CITY PLAN COMMISSION STAFF REPORT

Project Name
Falk Quarry Final Plat

Docket #C1

Request
CLD-FnPlat-2025-00011
Final Plat

Final Plat

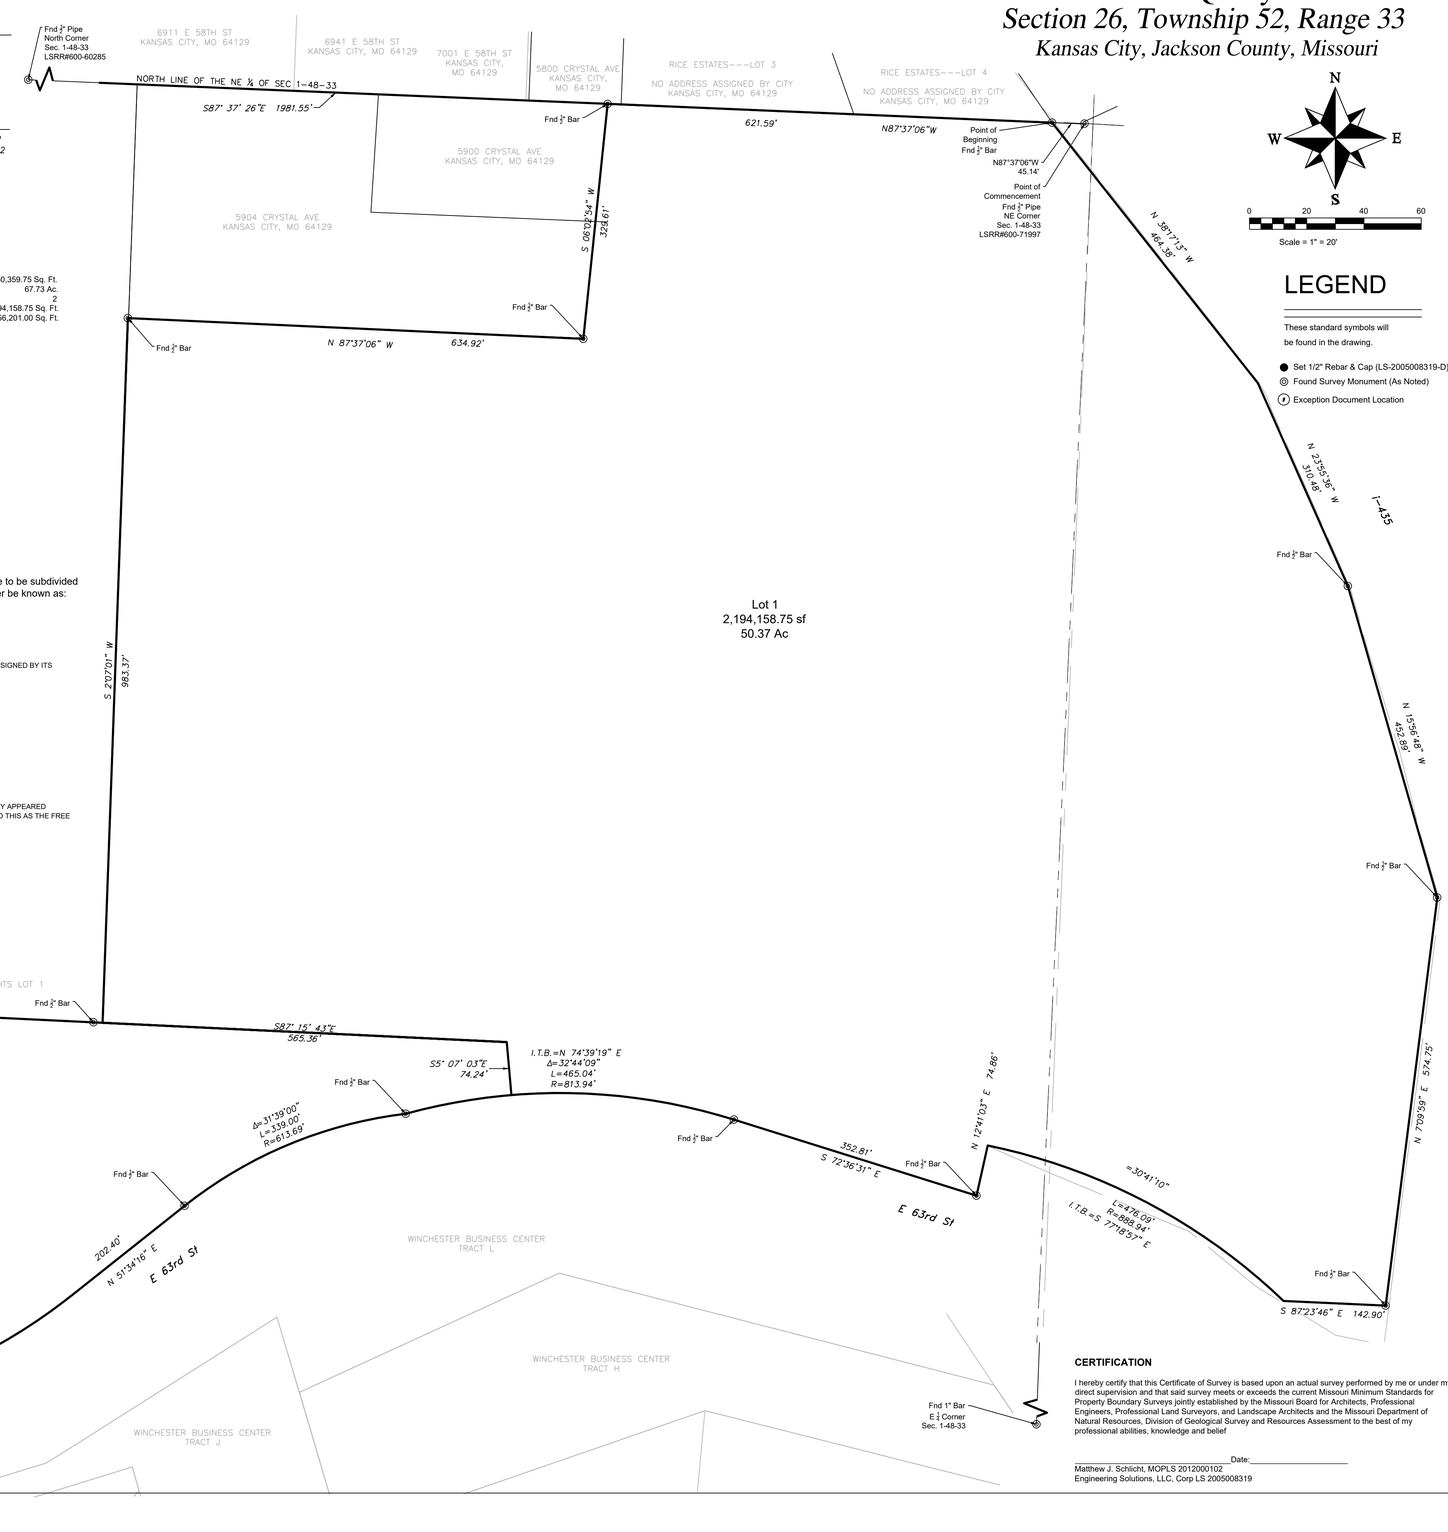
2. That prior to submitting documents for the final approval of conditions the applicant update the plat to reflect the correct City Plan Commission Date, Ordinance Number, and Council Approval Date by utilizing the Official City Signature Block found under Table 8 in the 2025 Director's Minimal Submittal Requirements and insert Case No. CLD-FnPlat-2025-00011.

10. The developer must show the limits of the 100-year floodplain on the final plat and show the Minimum Low Opening Elevation (MLOE) of any structure on each lot that abuts a 100-year flood prone area (including detention basins and engineered surface drainage conveyances) on any plat and plan, as required by KC Water.
